Type 531A/RM

PRODUCT MODIFICATION INDEX

FIG. 3

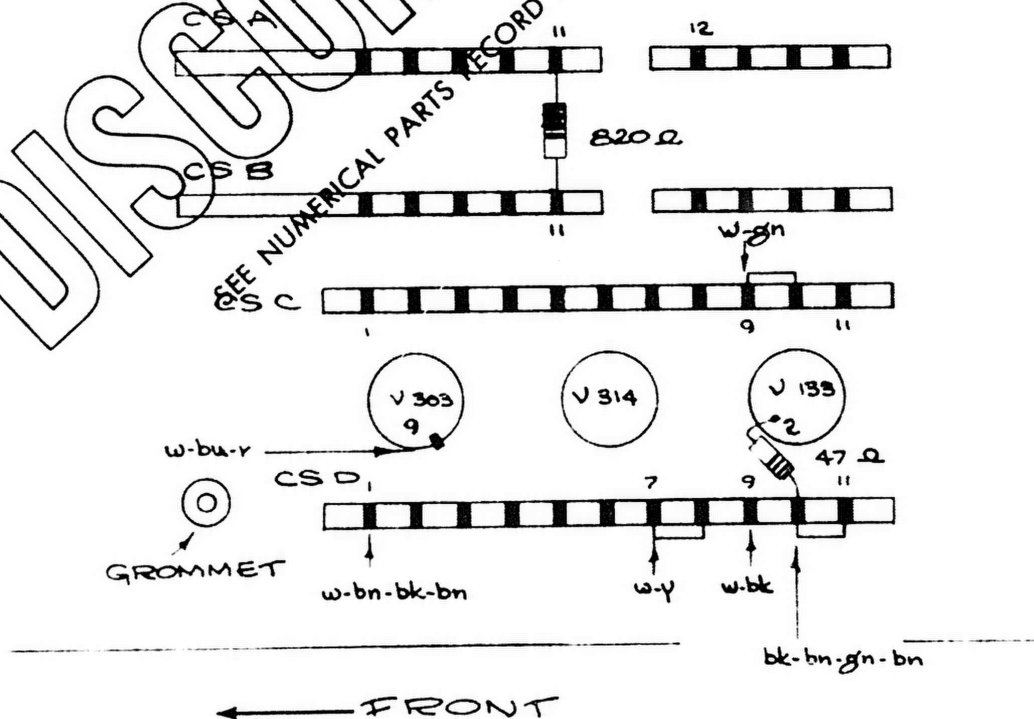
REFER TO FIG. 3 WHILE PERFORMING STEPS C-4 THROUGH C-6

- () 4. Locate the 1.5k resistor (R43) connected between CSA-11 and CSB-11.
- () Replace the resistor with the 820Ω 1/2W resistor from the kit.
- () 5. Locate and temporarily remove the 180k resistor (R116) connected between CSC-10 and CSD-10 (not shown in Fig. 3).
- () Move the end of the 47Ω resistor (R121 -- other end connected to pin 2 of V133) from CSC-10 to CSD-10.
- () Resolder the 180k resistor.
6. Solder the remaining wires from the cable as follows:
 - () white-blue-red to pin 9 of V303
 - () white-green to CSC-9
 - () black-brown-green-brown to CSD-10
 - () white-black to CSD-9
 - () white-yellow to CSD-7
 - () white-brown-black-brown to CSD-1

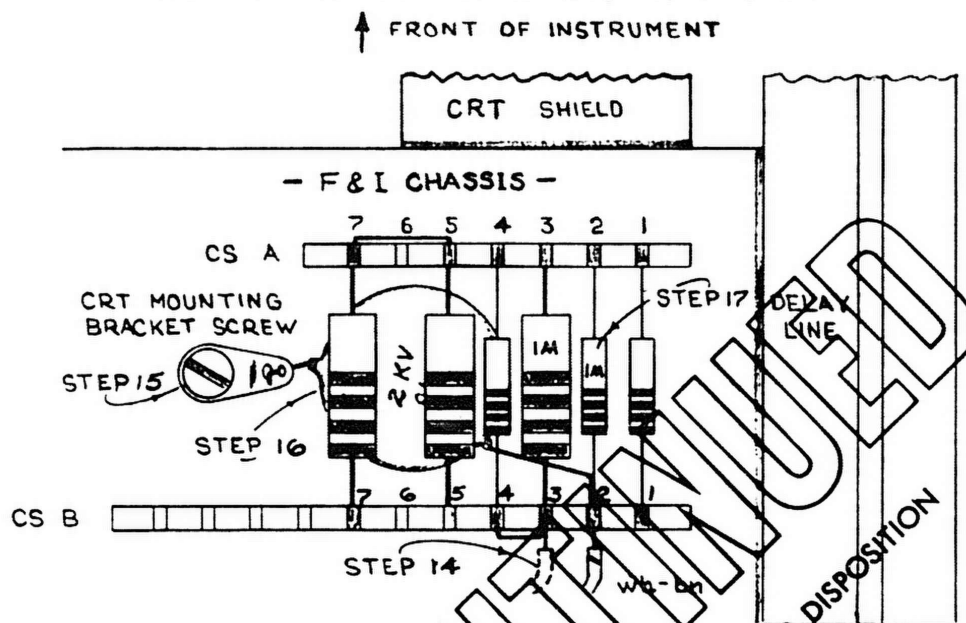
- () 12. Temporarily remove the high voltage shield at the top of the instrument above the CRT.
- () 13. Remove the bare wire (not shown) between CSA-1 and CSB-3. (See Fig. 1.)
- () 14. Unsolder the white-brown wire at CSB-3 and move the wire to CSB-2 (Fig. 1, Step 14).

- () 15. Mount the solder lug (from kit) under the CRT mounting bracket screw (on instrument). Place the solder lug between the screw head and the flat washer (Fig. 1, Step 15).

FIG. 2

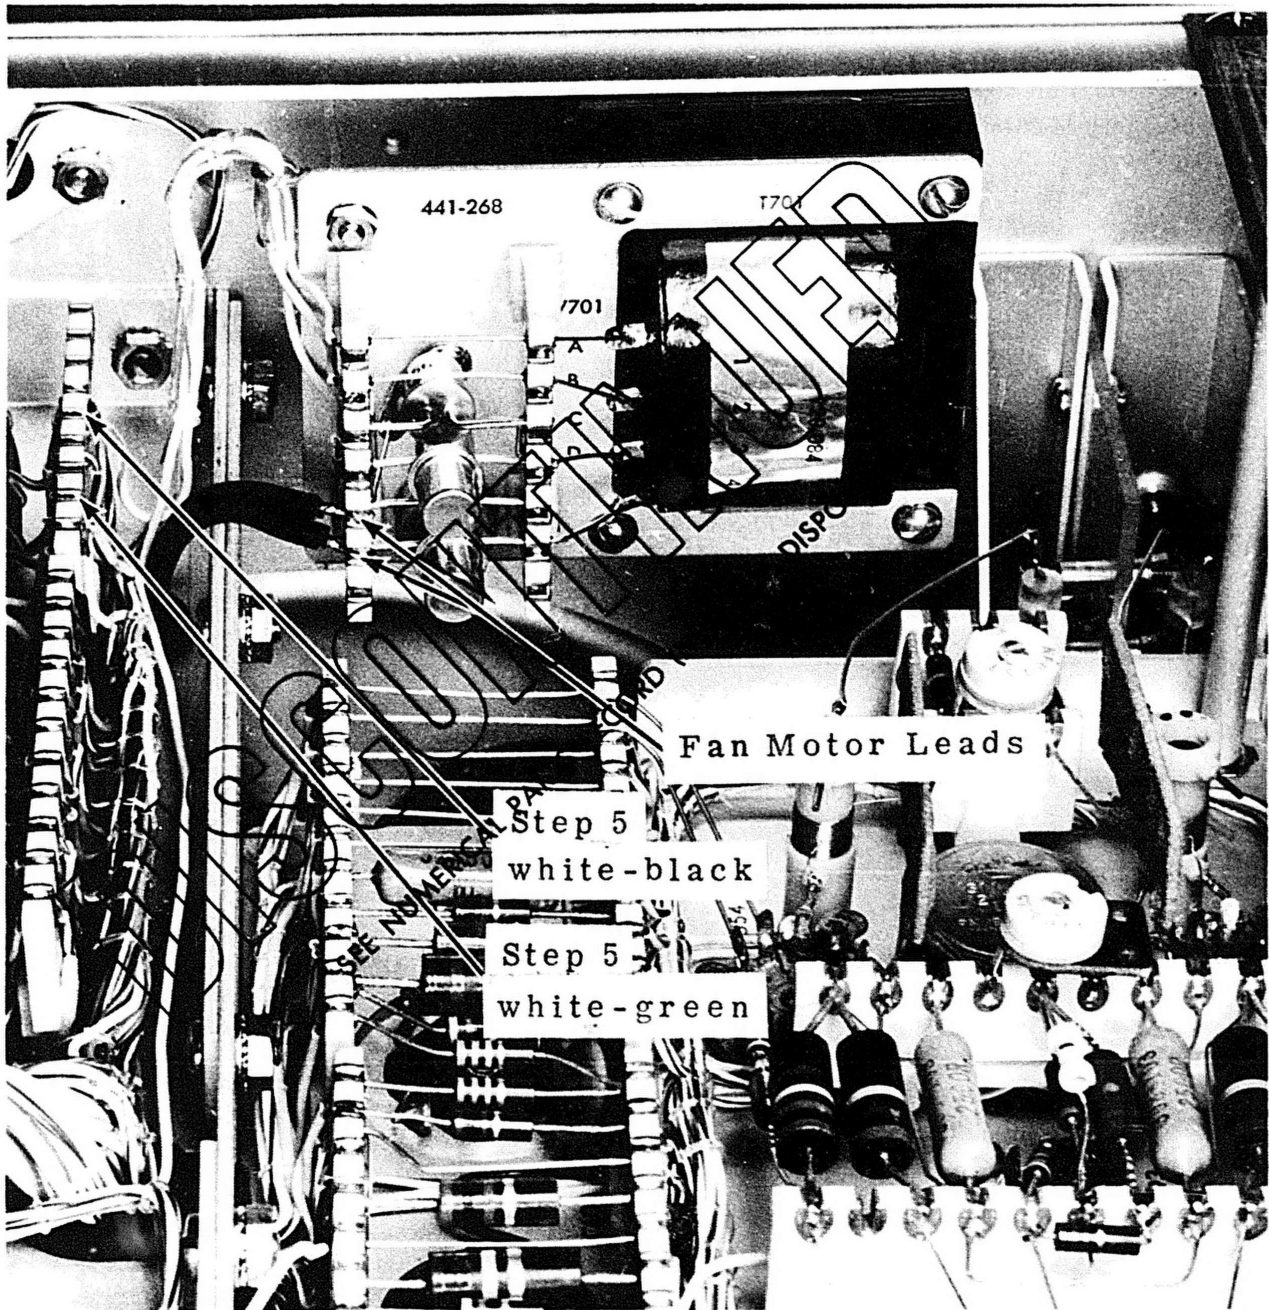
- () 16. Mount the .01 μ f discap (from kit) parallel to the chassis and about 1/4 in. below the 2 w resistors. Solder one (1) lead to the solder lug and the other lead to CSA-2 (Fig. 1, Step 16).
- () 17. Solder the 1 meg resistor (from kit) between CSA-2 and CSB-2 (Fig. 1, Step 17).
- () 18. Lay the neon bulb assembly over the two 1 meg resistors, as in Fig. 2. Solder the leads at CSA-2, CSB-2 and CSB-3. Do not cut the lead attached to CSA-2. Dress the leads so they do not touch the resistors.
